ADDENDUM No. 3

**ORG #207 – San Jacinto Elementary School - Renovation
ORG #273 – Pleasant Grove Elementary School – Renovation**

DALLAS INDEPENDENT SCHOOL DISTRICT

11/01/2024

SITE PLAN

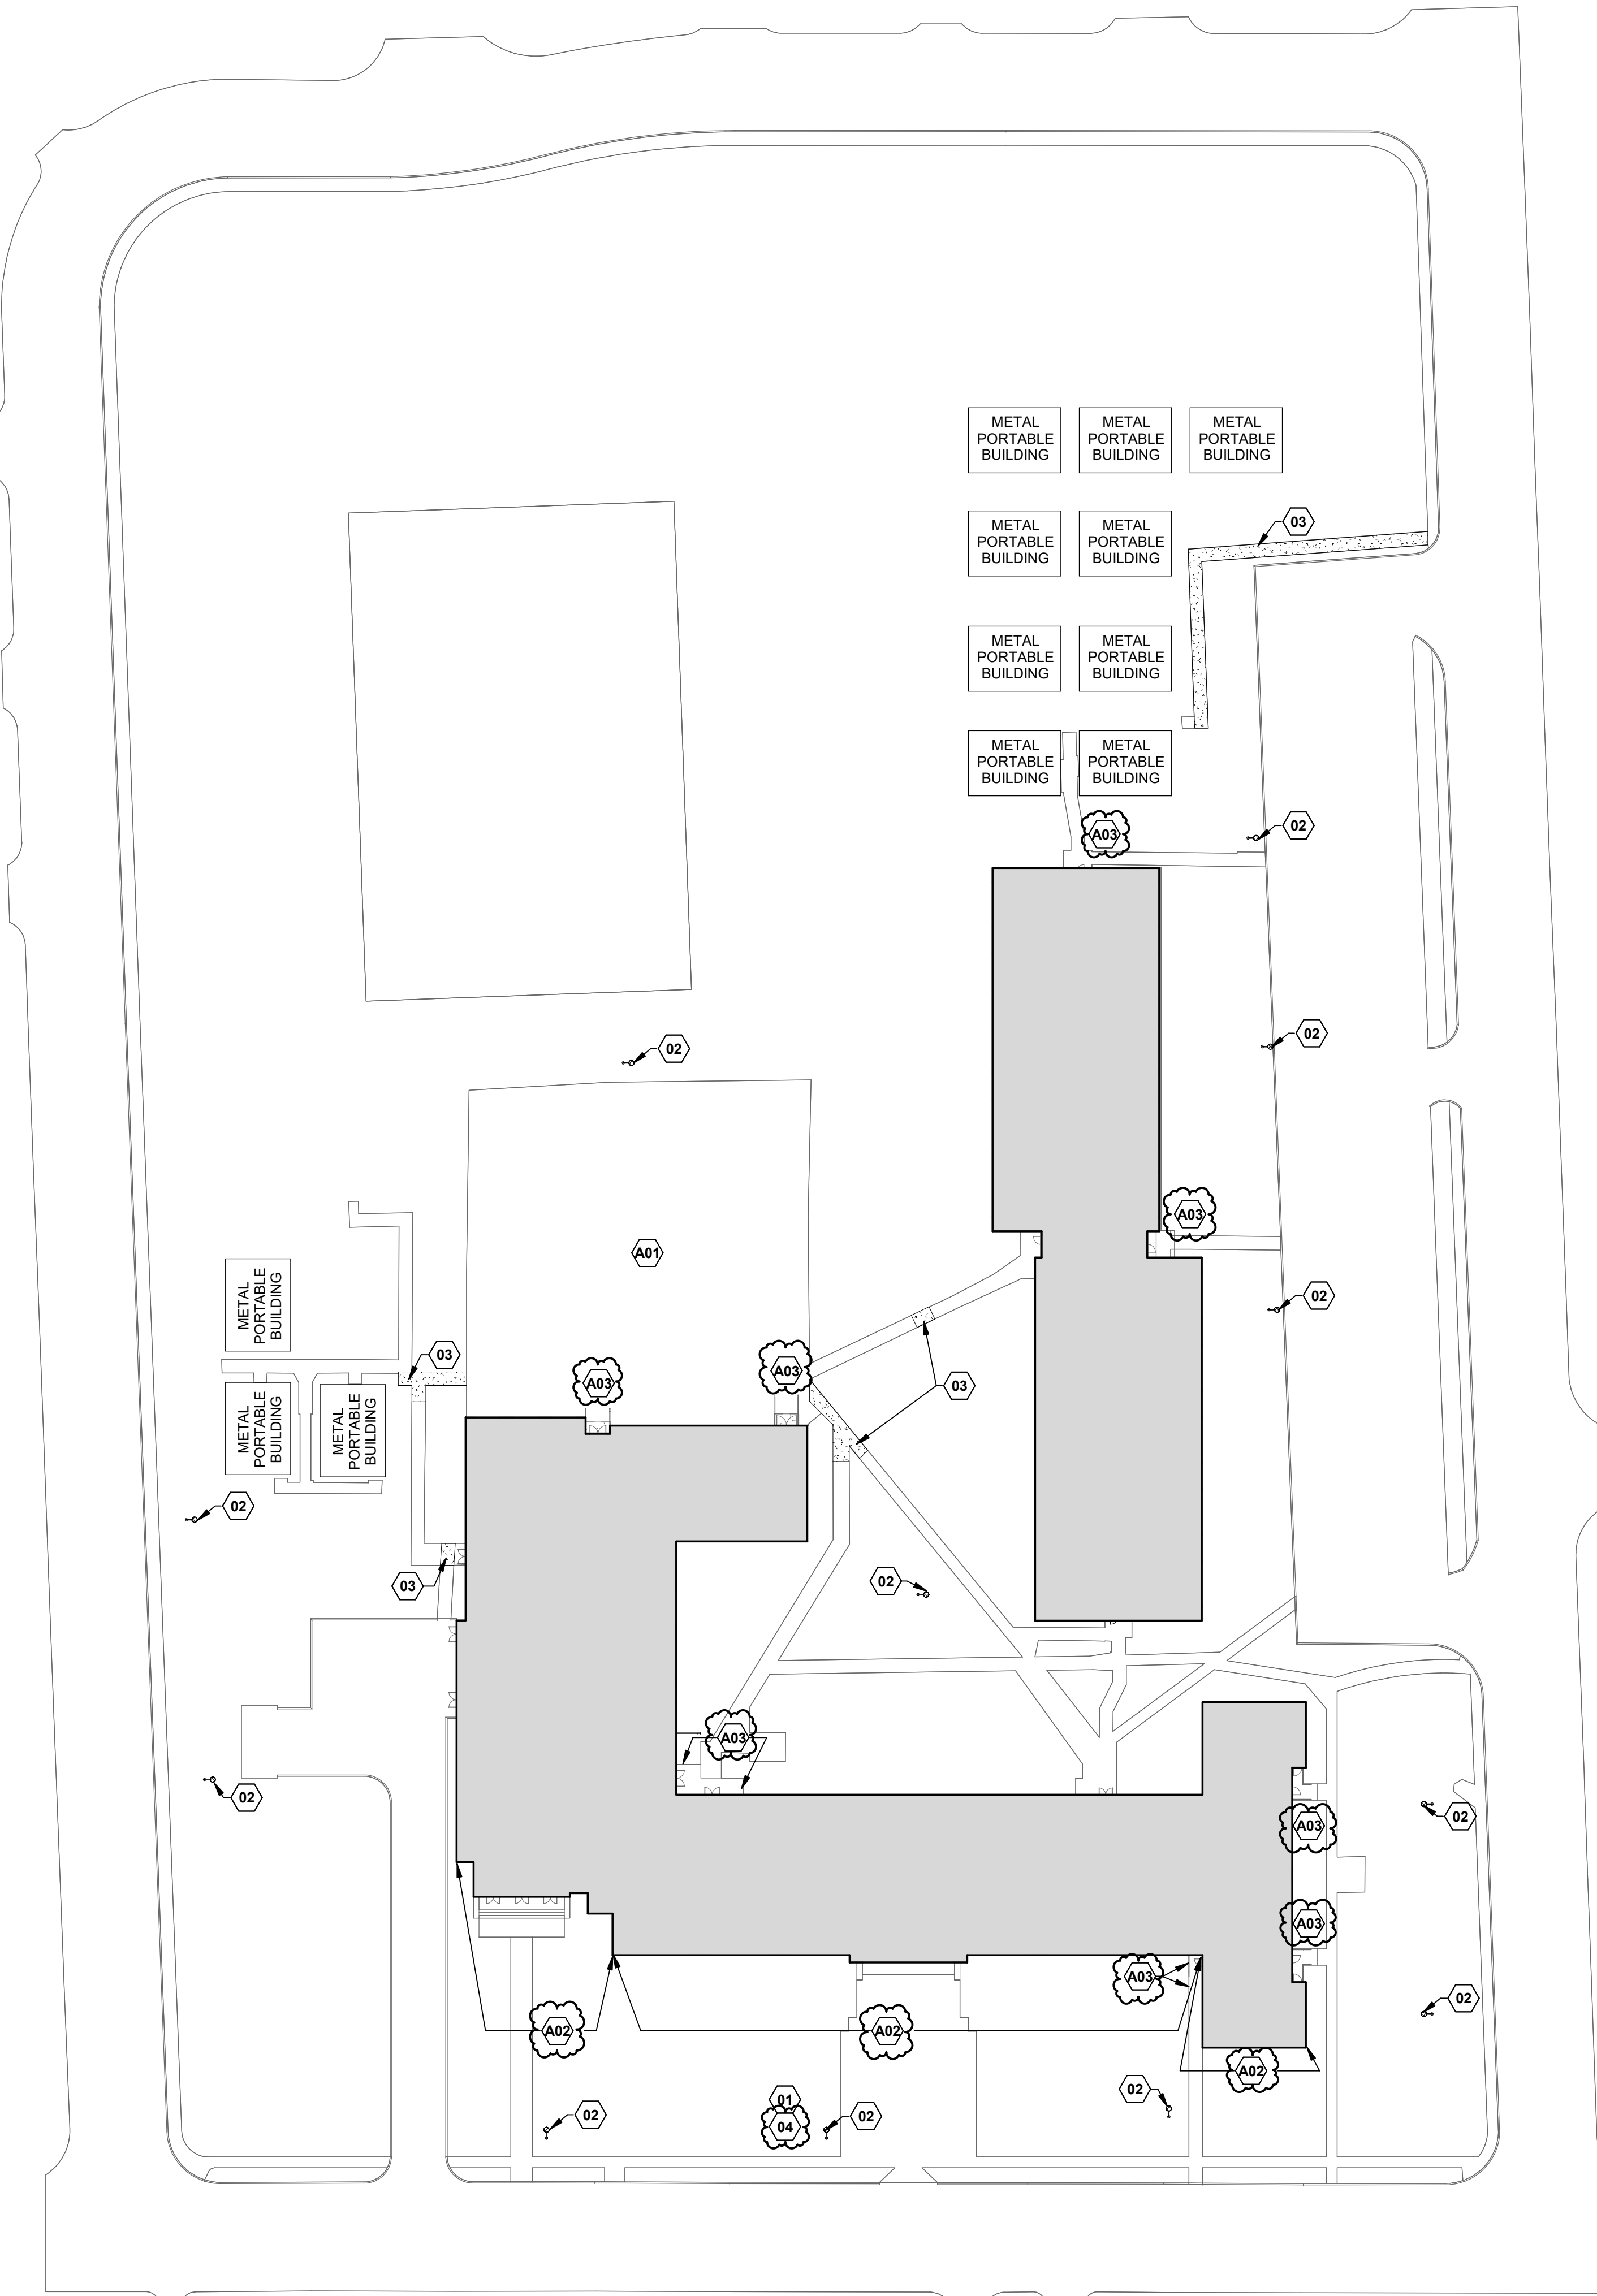
- Replace sheet with the revised attached A1.02.
 - Add note: Ensure UPN fiber running into building will not be affected by marquee excavation. If UPN fiber needs to be relocated, notify DISD.
- Replace sheet with the revised attached S2.01.
 - Add note: Ensure UPN fiber running into building will not be affected by marquee excavation. If UPN fiber needs to be relocated, notify DISD.
- Replace sheet with the revised attached R1 and R2
 - Add note: If there are adjustments to the existing roof openings or conflicts with the existing structure regarding roof top units, contact the Architect/EOR.

- 01 REMOVE AND REPLACE WITH NEW DIGITAL MARQUEE SIGN.
- 02 REPLACE EXTERIOR LIGHTS WITH LED LIGHTING AND PROVIDE EXTERIOR LIGHTING CONTROLS. REFER TO MEP.
- 03 REMOVE AND REPLACE DAMAGED CONCRETE SIDEWALKS. REFER TO CIVIL.
- 04 IF UPN FIBER NEEDS TO BE RELOCATED, NOTIFY DISD IMMEDIATELY.

PARTIAL PLUMBING ROOF PLAN 'B1'

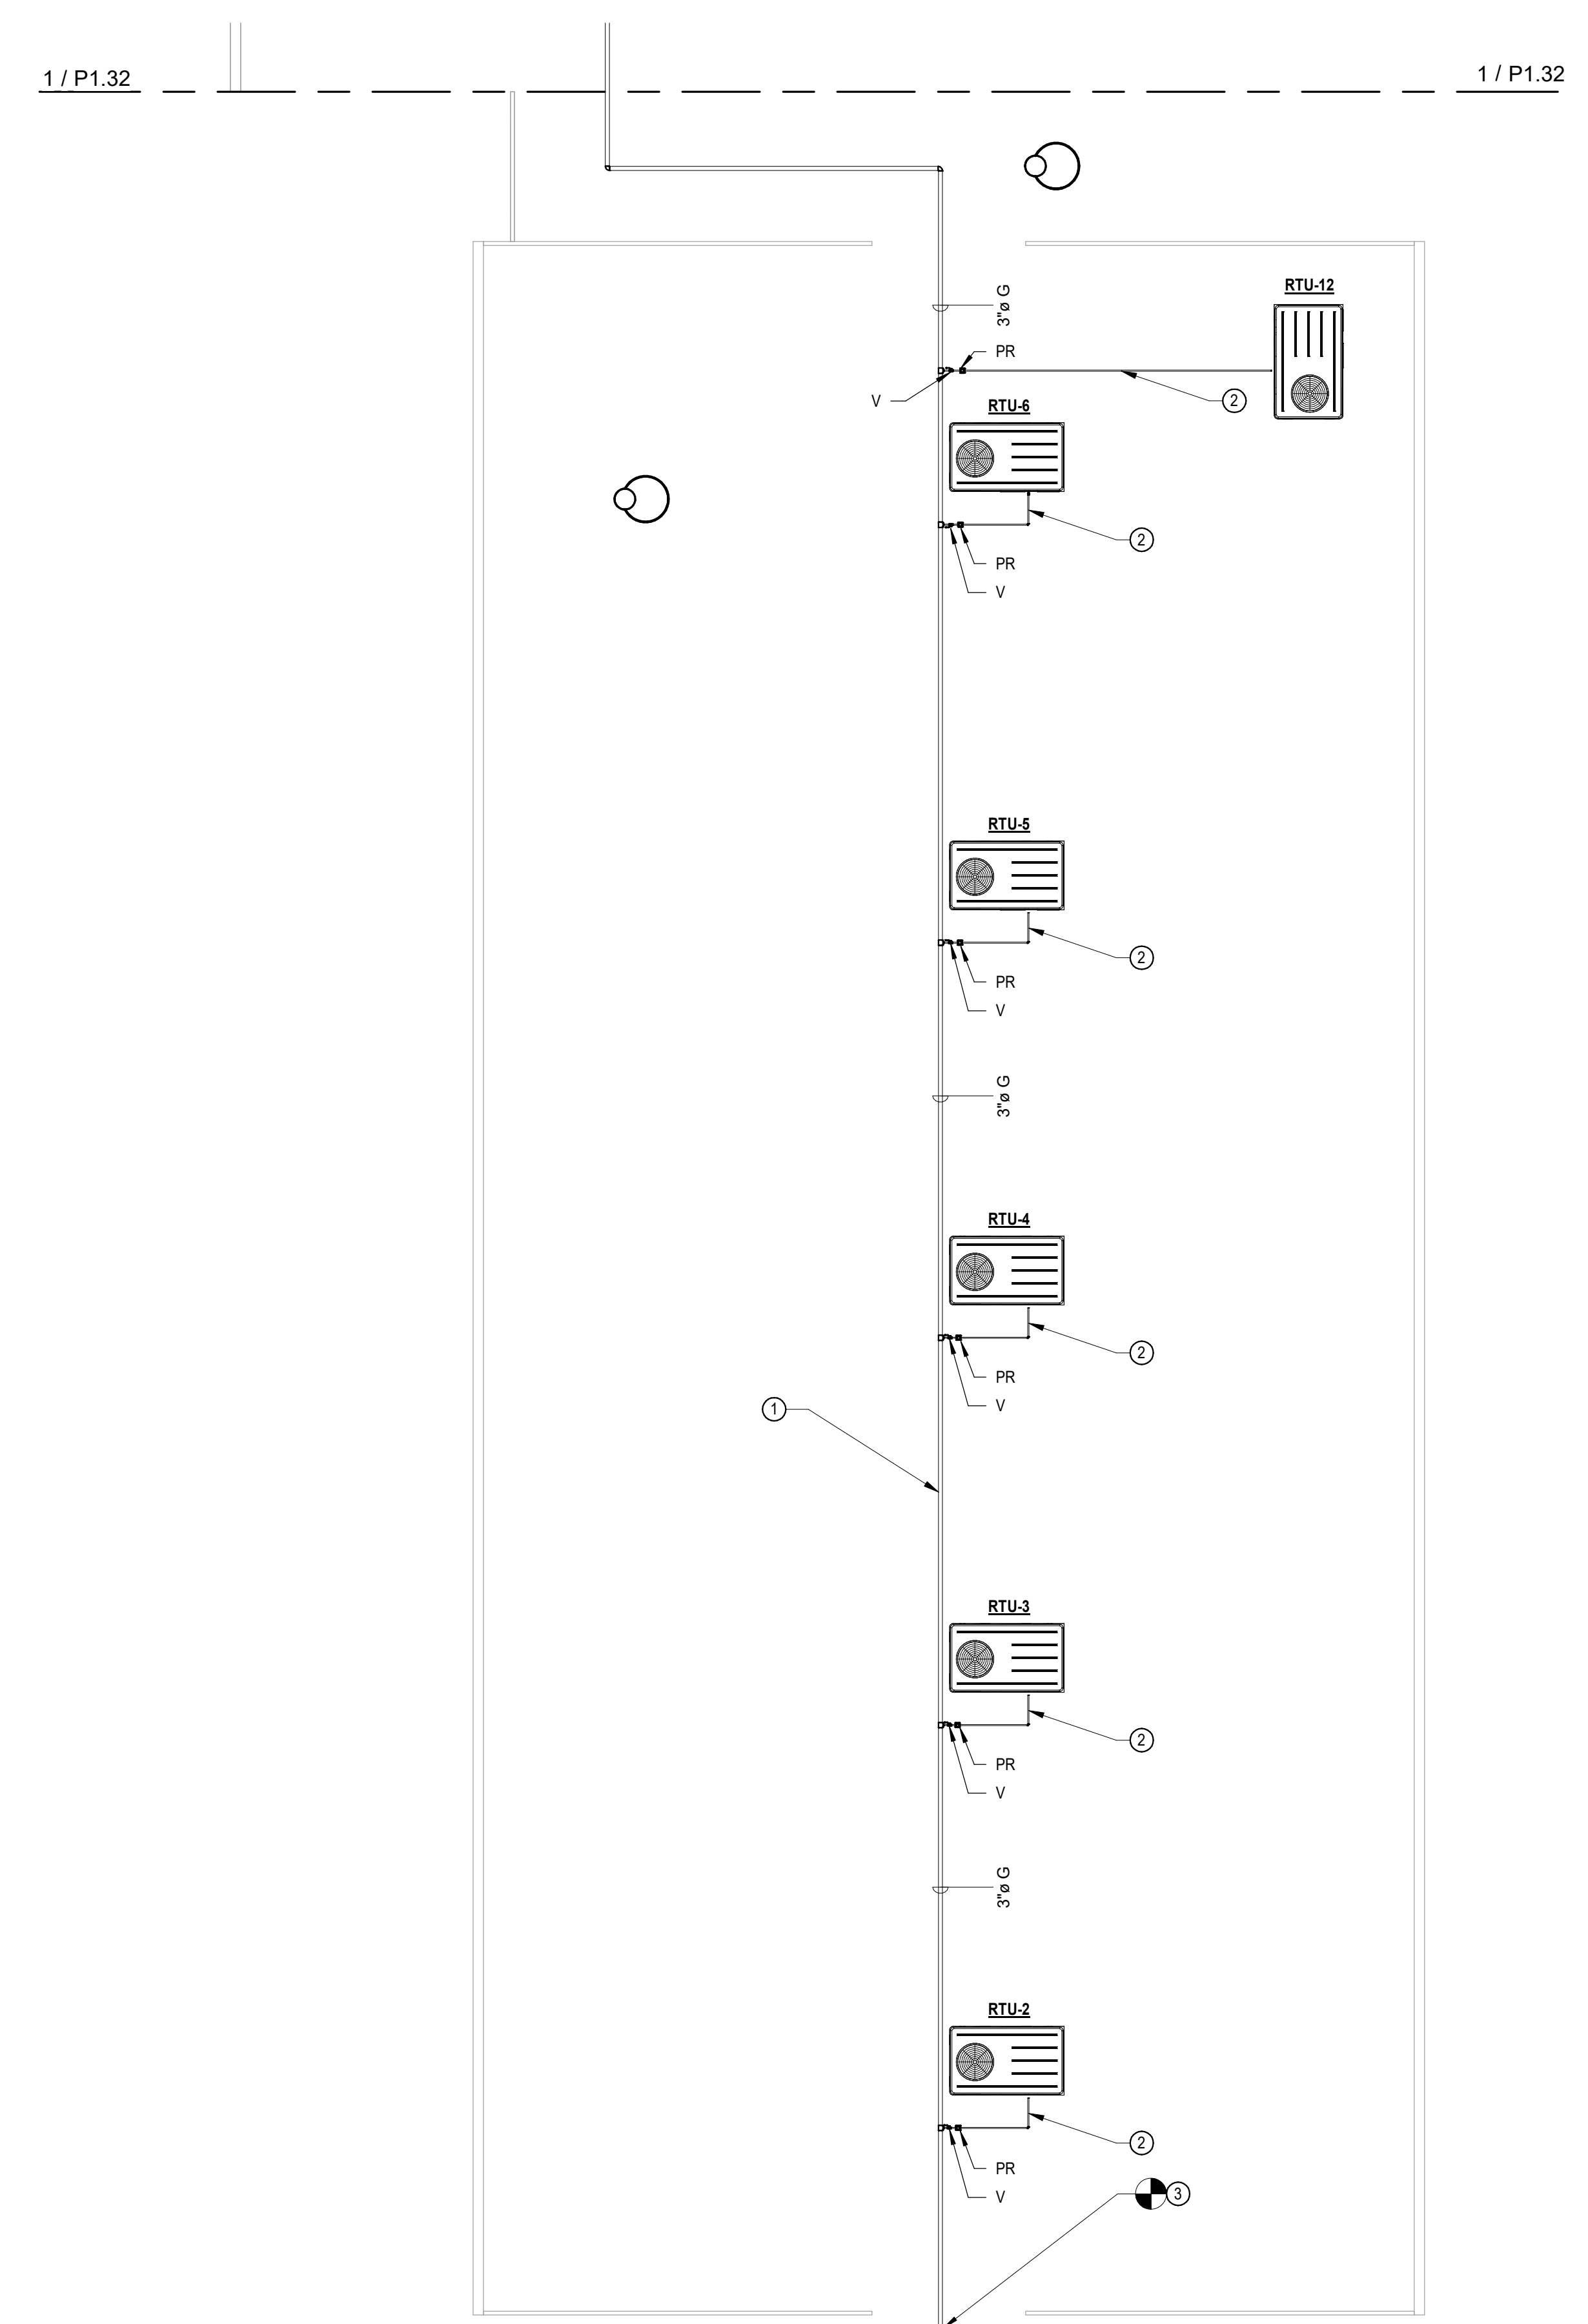
- Updated note #1 to include painting of new gas piping as indicated.
- Replace sheet with the revised attached C3.00.
 - Fence scope removed as indicated.

- NOTES BY SYMBOL:**
- 1 PROVIDE NEW GAS PIPING AND ROOF SUPPORTS. PROVIDE NEW GAS PIPING AT SAME SIZE AS EXISTING. FIELD VERIFY EXACT SIZE OF GAS PIPING PRIOR TO INSTALLATION. GAS PIPING TO BE PAINTED. COLOR TO BE APPROVED BY ARCHITECT.
 - 2 PROVIDE RTU WITH NEW 3/4" GAS PIPING CONNECTION (SEE DETAIL). PROVIDE WITH PRESSURE REGULATOR AND ISOLATION VALVE.
 - 3 CONNECT NEW GAS PIPING TO EXISTING RISER ALONG EDGE OF BUILDING. PROVIDE NEW GAS PIPING AT SAME SIZE AS EXISTING. FIELD VERIFY EXACT SIZE OF GAS PIPING PRIOR TO INSTALLATION.
